REVISED DA DRAWINGS

DA SUBMISSION – LDA2020/169

BUILDING AB : 45-61 WATERLOO ROAD, MACQUARIE PARK NSW 2113

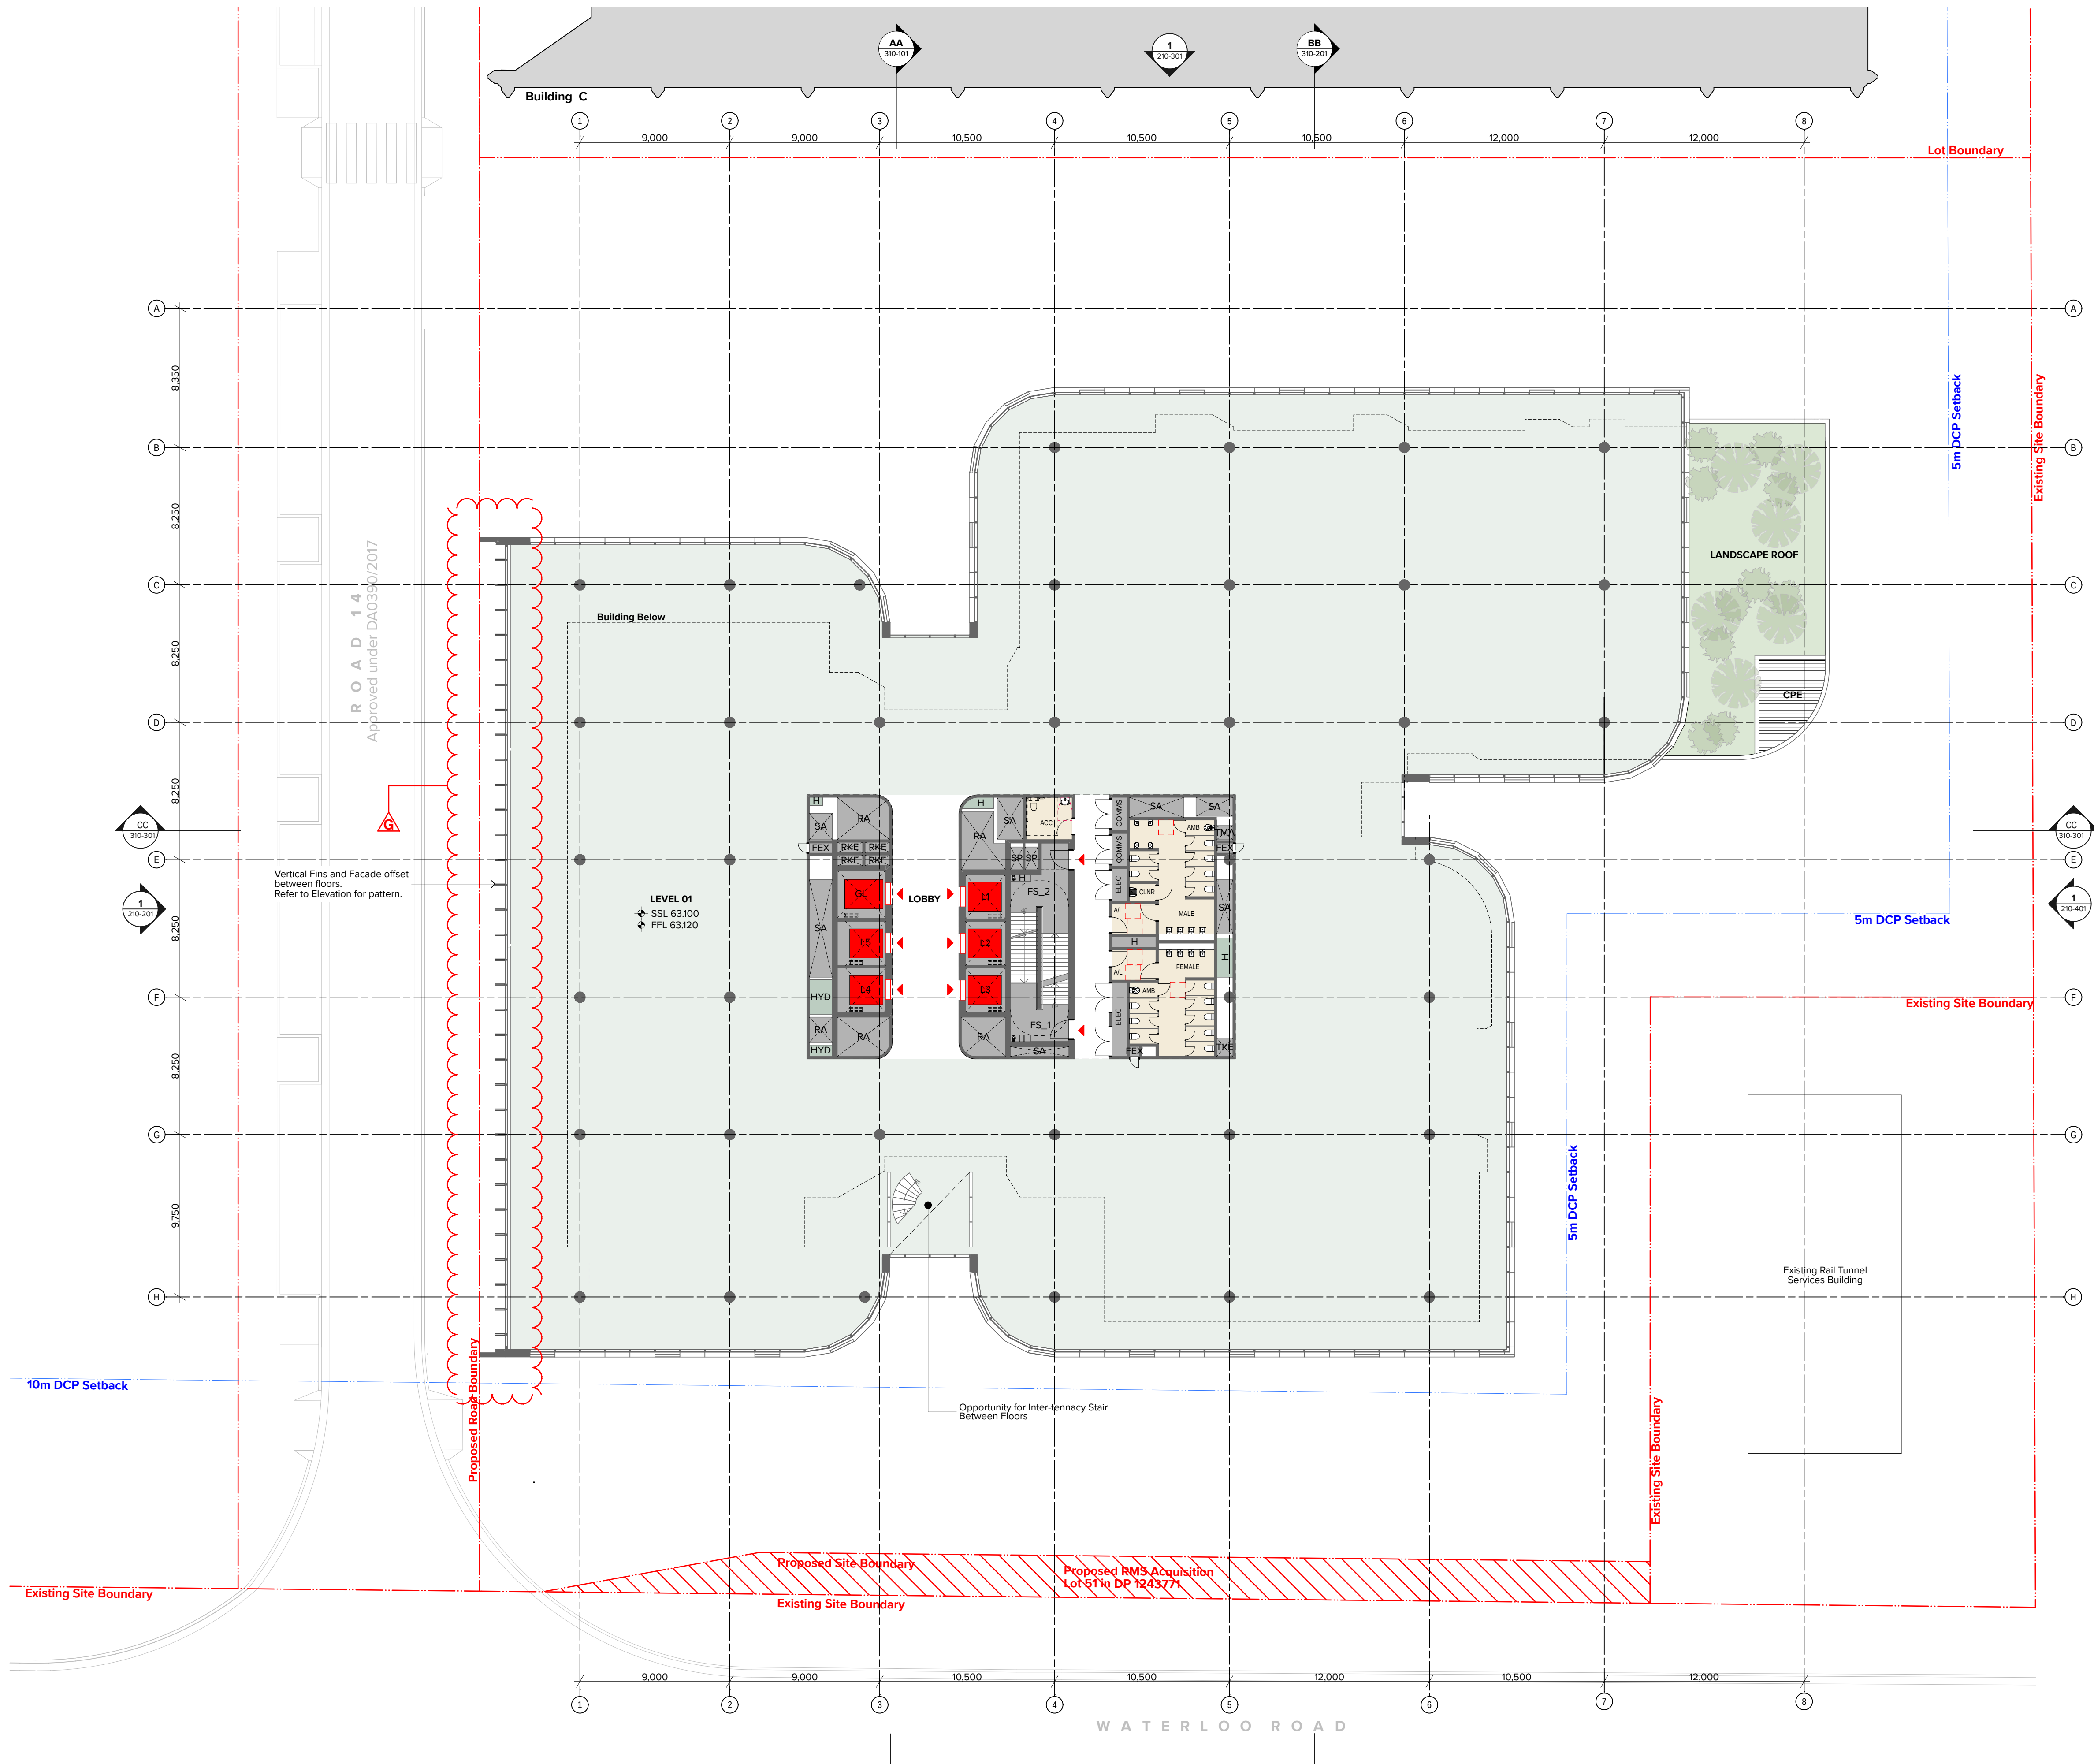
- *It is recommended that other than relying on shading devices, the Applicant may consider additional solutions to refine the building bulk and scale and add visual interest. It could include providing deep shaded slots, balconies and landscape planting to the façade. Providing variation to the roof line of the projected hood/framing element can also add visual interest to the silhouette of the development when viewed from the park.*

In response to the concerns raised above, we believe that the resulting façade character following the integration of the offset vertical fins, provides a sufficiently improved outcome in terms of reducing the perceived bulk and scale of the Western Elevation. As outlined previously, the modifications provide a rhythm and high level of visual interest across the extent of the façade. The proposed amendments provide a unified response that is consistent with the overall building form and character.

Drawing Title
**Elevations
West Elevation**

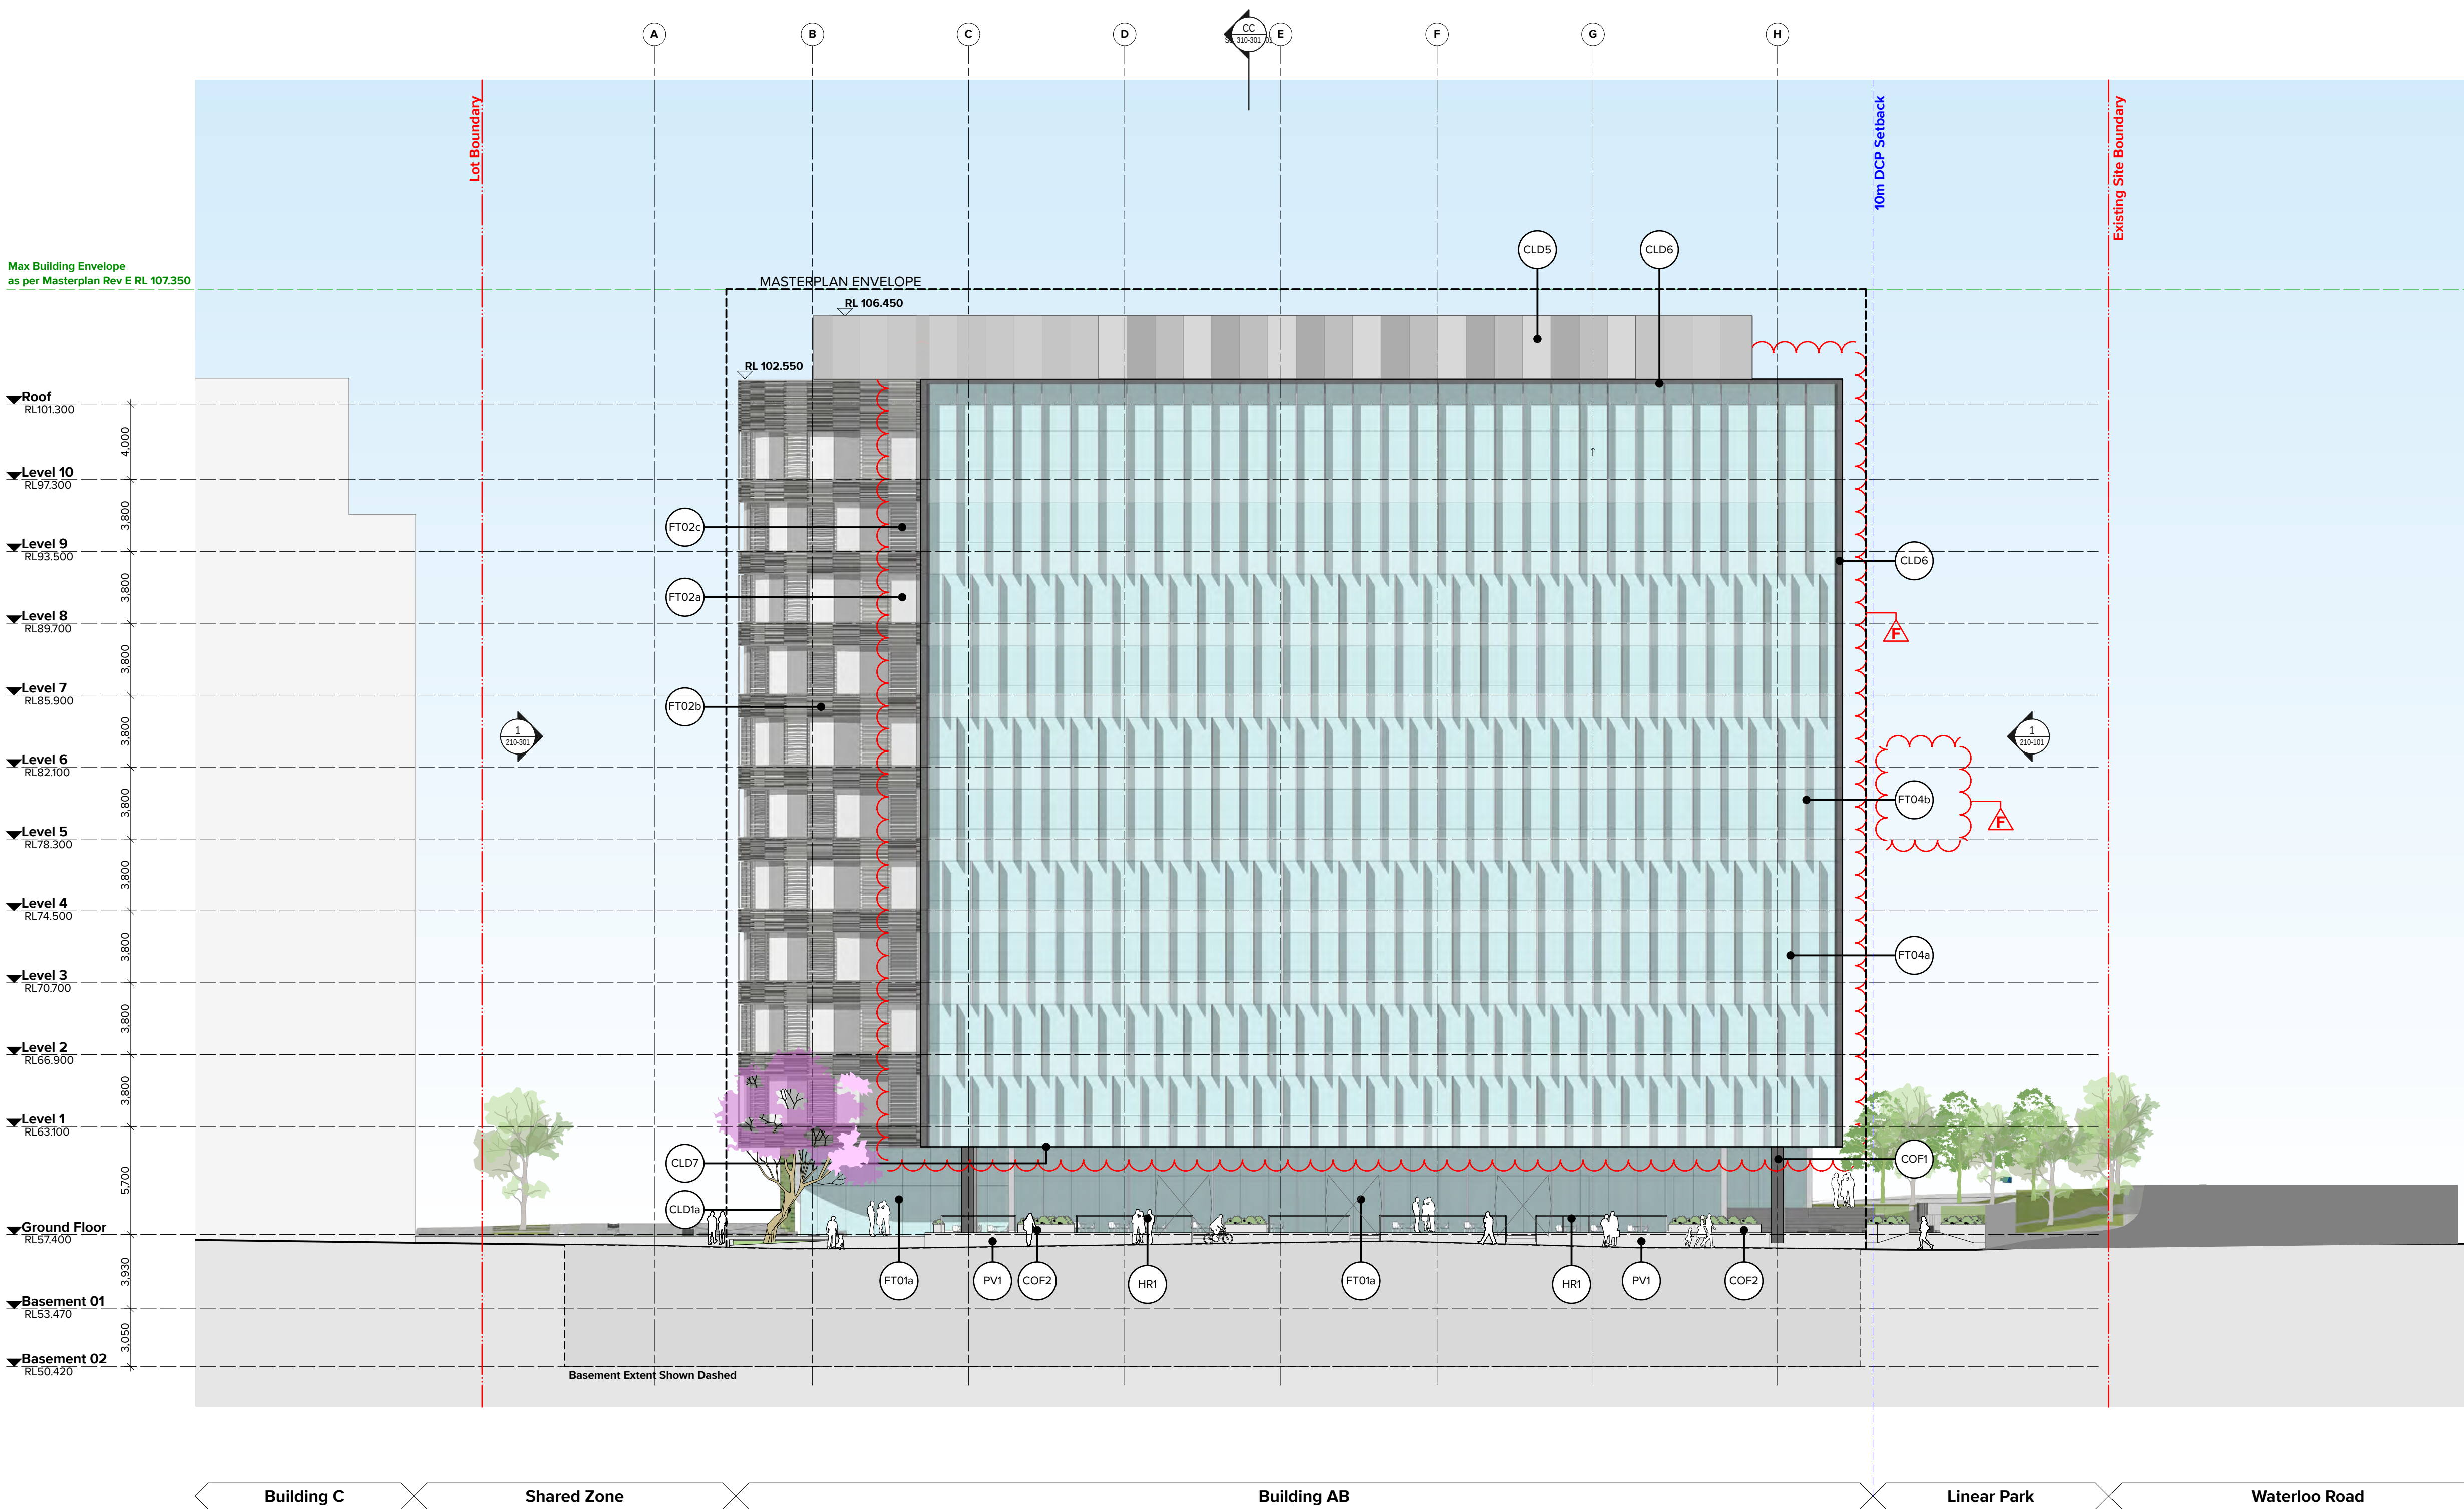
- *The west elevation presents an extensive (40m high x 48m wide) glazed façade to the park. The 600mm deep horizontal shading elements provided to each floor add rhythm to the façade, but are insufficient to break up the perceived building bulk. The presentation of the west elevation is particularly important as it will be highly visible from the park, Waterloo Road and adjacent development. It contributes significantly to the visual quality of the precinct and therefore careful consideration is required for the articulation of its west elevation.*

As pointed out by the UDRP, the narrow horizontal elements are insufficient to mitigate the western sun. Vertical elements are known to be more effective on east and west elevations for providing shade. The Applicant may consider introducing a prominent vertical element to visually break up the length of the façade and increase shading to the internal space.

In response to the comments outlined above, the Western Façade has been modified to integrate vertical shading elements to assist in providing a variety of scale across the extent of the façade, as well as to further improve the thermal performance of the façade.

Vertical perforated fins that are offset provide a rhythm that reduces the perceived extent of façade. The variation in rhythm adds visual interest and facilitates a sense of movement and a variety in scale across the Western elevation.

The fins have been designed to maximise the amenity of the office floor plates. The perforated metal allows controlled daylight to filter internally, and maintains a high level of visual outlook amenity to Catherine Hamlin Park.

The performance of the vertical fins have been reviewed by LCI for solar shading effectiveness and a detailed response has been provided in separate letter by LCI (dated 15th March 2021.) The integration of vertical fins has improved the solar performance of the Western façade, and meets the Section J requirements.
